RESPONSE LETTER NO. 3 TO REQUEST FOR INFORMATION

Project Title: **Unit Substation Equipment Replacement – Phase 1**
Project No.: **TP-0000008861 (MCC 7040 Plan)**

Auto Throwover Diagram for RFI No. 3

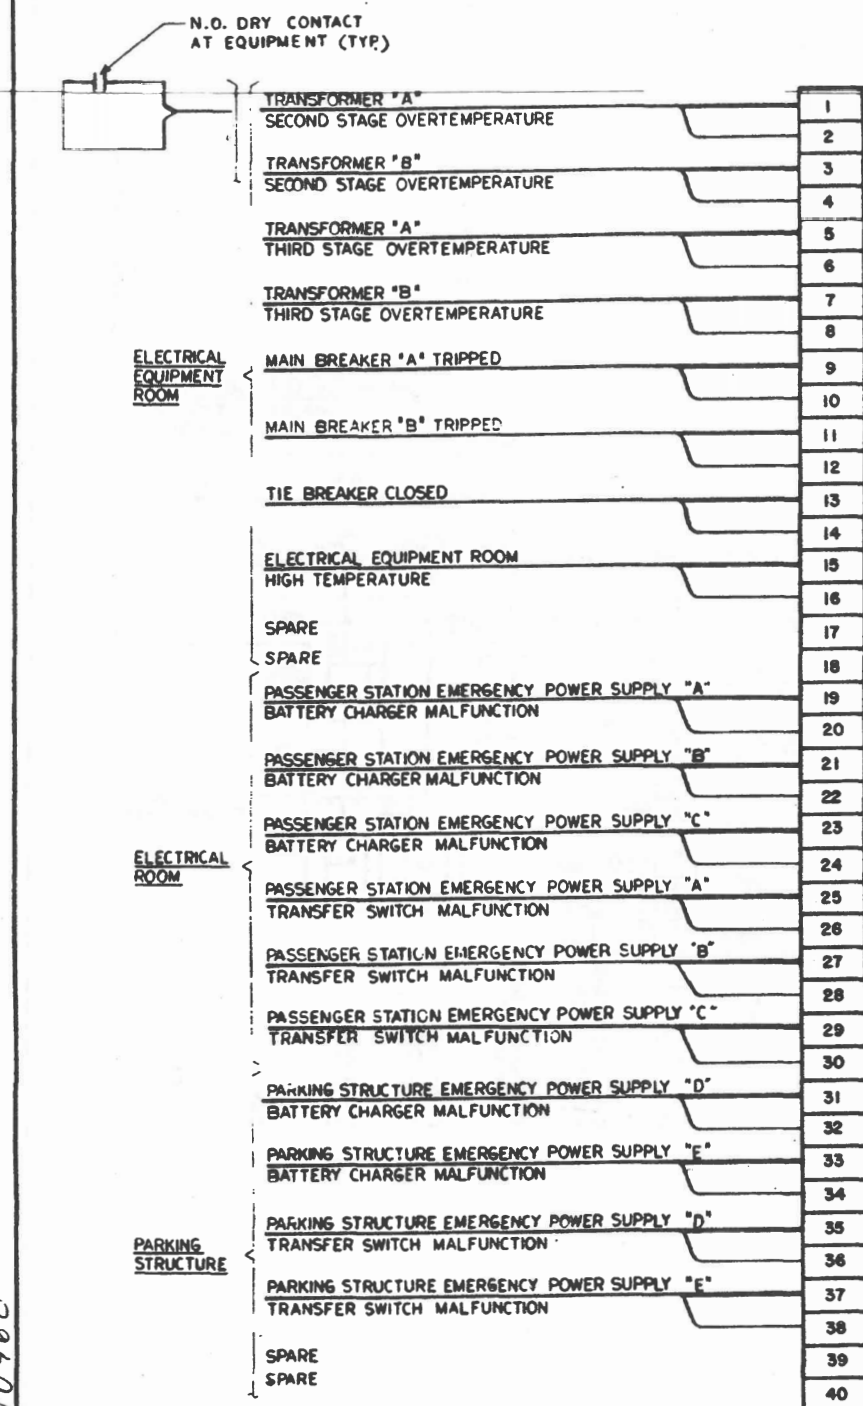
- QUESTION: 3) There are multiple references to an “Automatic Transfer System” between the Main 1 Tie Main 2 on the incoming side of the 480V switchboards. Please provide full Description of the Automatic Transfer System including Local /remote operation and Test Button requirements?

- RESPONSE: 3) In normal operating mode, main breaker A is closed, main breaker B is closed, and tie breaker is open. In the event of loss of power on feeder A, main breaker A is open, main breaker B is closed and tie breaker is closed. In the event of loss of power on feeder B, main breaker A is closed, main breaker B is open and tie breaker is closed. Please see attached Auto Throwover Diagram under this RFI No. 3.

Dadeland North IO list for RFI. No. 3

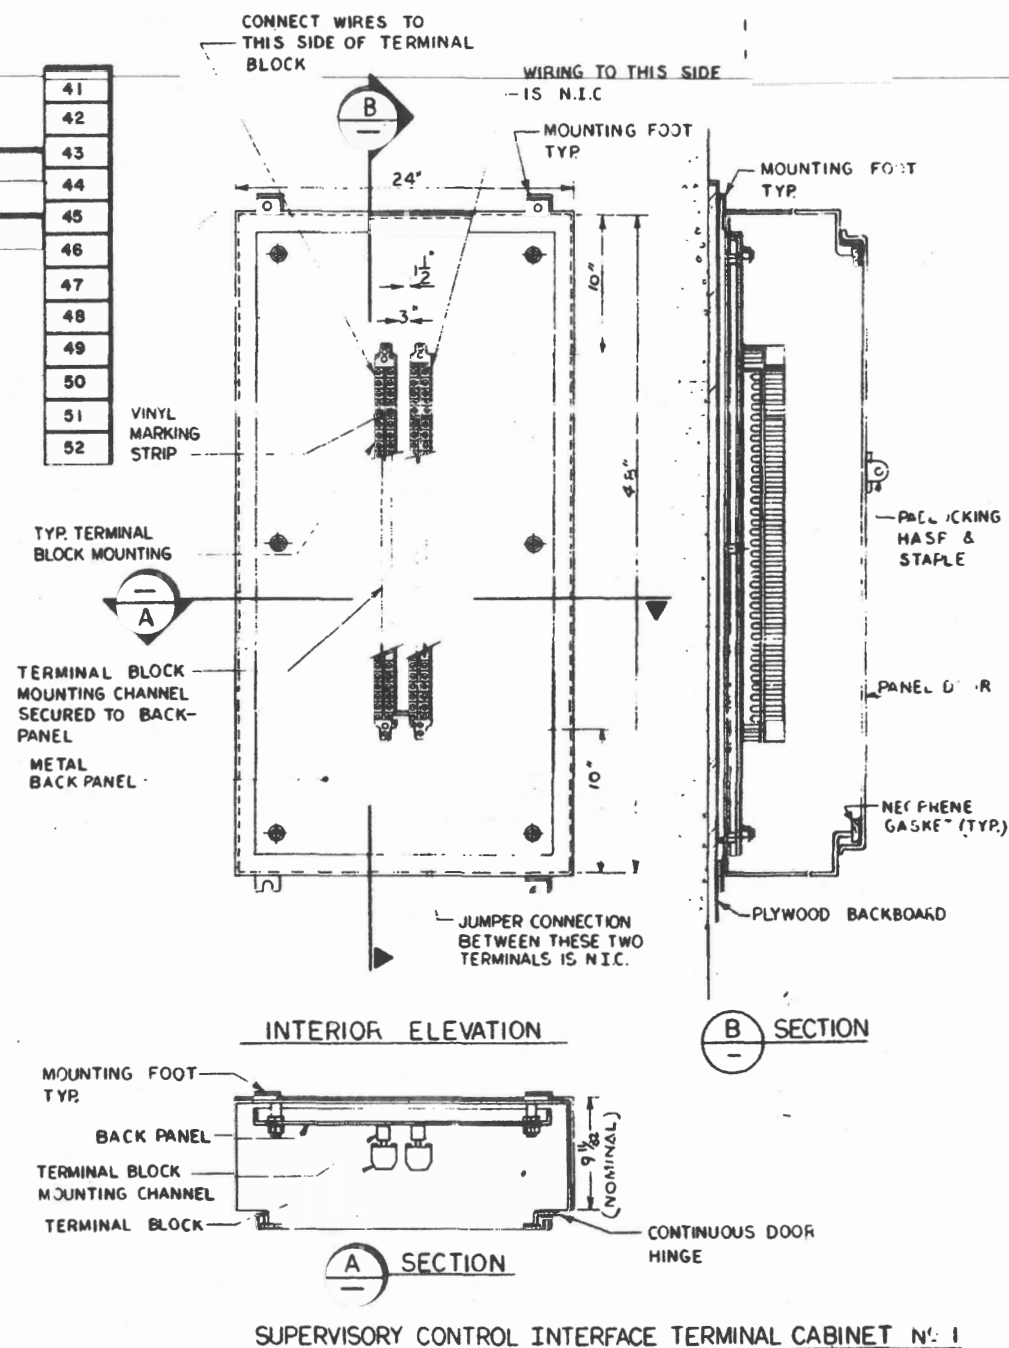
- QUESTION: 2) There are multiple references to SCADA or indications throughout section 01 11 00. The Package does not provide any details on the amount of Local or remote indications or the nature of the transmission of these signals to Central Control / Local annunciators. Please provide SCADA I/O List for each location Shop Drawings of Local SCITC Cabinets as well as local annunciation requirements?

- RESPONSE: 2) Existing Supervisory Control Interface Terminal Cabinet (SCITC) and existing functionality shall remain in place. Contractor shall connect new equipment to existing SCITC cabinet and verify functionality. No other equipment changes are envisioned. Please refer to SCITC attachments under this RFI No. 3.
